January 25, 2019

Safety Recall: ILX Fuel Tank Production Date Inspection

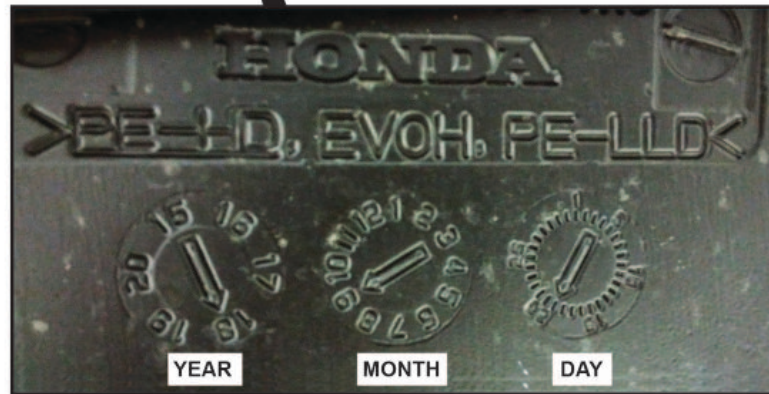
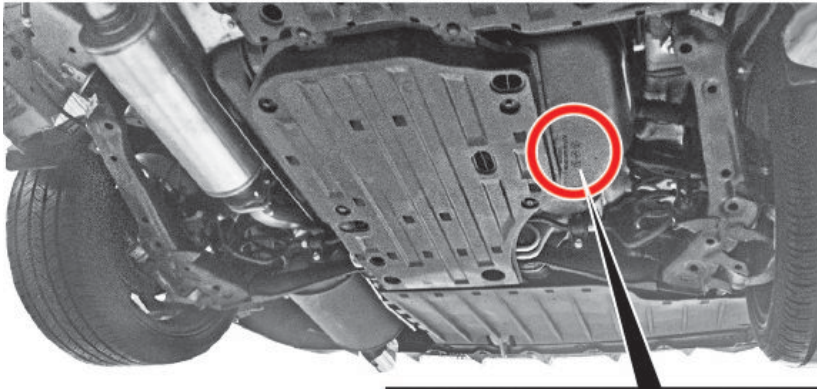
1. Visually inspect the fuel tank's blow mold date (see illustrations below).

Year	Month	Day
2017	10	2, 3, 6, 7, 20, 21
2018	6	20, 21, 25
	7	20
	8	6, 7, 29, 30
	9	3, 9, 10, 13, 14, 19, 20
	10	24, 25, 31
	11	1

- If the fuel tank was produced on any of the dates listed above, go to step 2.
 - If the fuel tank was not produced on any of these dates, no further action is required.
2. Write down the mold date on the repair order, then remove and install the fuel tank. See the service information for details.
